UNITED STATES PATENT AND TRADEMARK OFFICE

APPLICATION NO.	FILING DATE	FIRST NAMED INVENTOR	ATTORNEY DOCKET NO.	CONFIRMATION NO.
10/010,892	11/05/2001	Bradley W. Plattner	GRD0128.US	3059

Office Action Summary

DETAILED ACTION

FIG. 1

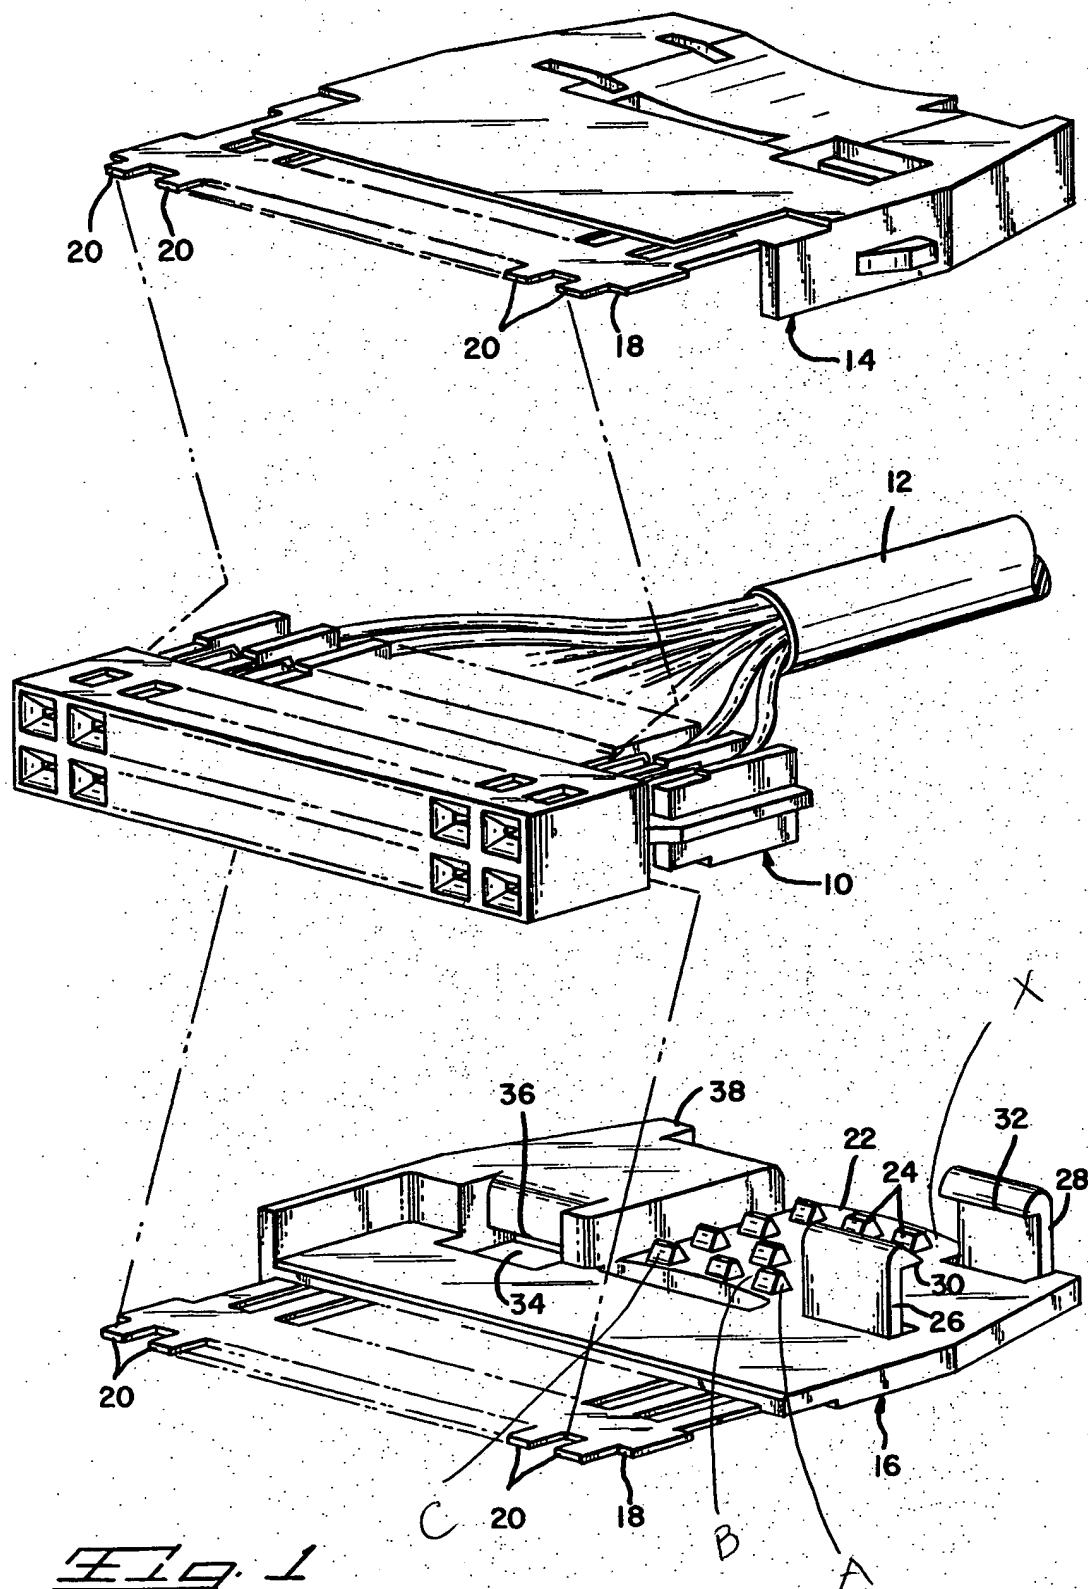
- a plurality of electrical conductors (46);
- a sleeve (12, a sheath for a cable) carries the plurality of electrical conductors (column 1, lines 31-33); and
- a connector (10 and 14, 16, a connector and a cover members, respectively) comprises a housing which including a first end has an opening with an inner surface (X, attachment) to accommodate the sleeve and the plurality of electrical conductors. The inner surface has a plurality of pointed projections (24, a plurality of teeth), each of the pointed projections has a ramped side (A, attachment), which is extending farther from the inner surface in a direction away from the opening.

✓ Regarding claims 3 and 10, Douty et al., figure 1, disclose an adjacent side (C, attachment) of the pointed projections forms an obtuse angle with the inner surface.

✓ Regarding claims 4 and 11, Douty et al., figure 1, disclose each of the pointed projections has a front side (B, attachment) which opposing with the ramped side and adjacent to two adjacent sides (C, attachment). The front side being generally perpendicular to the inner surface.

✓ Regarding claims 5-6 and 12-13, Douty et al., figure 1, disclose the plurality of pointed projections are formed a plurality of rows on the inner surface.

Douty et al., figure 1, disclose the pointed projections include two adjacent sides (C, attachment) being adjacent to the ramped side that is extending from the inner surface.
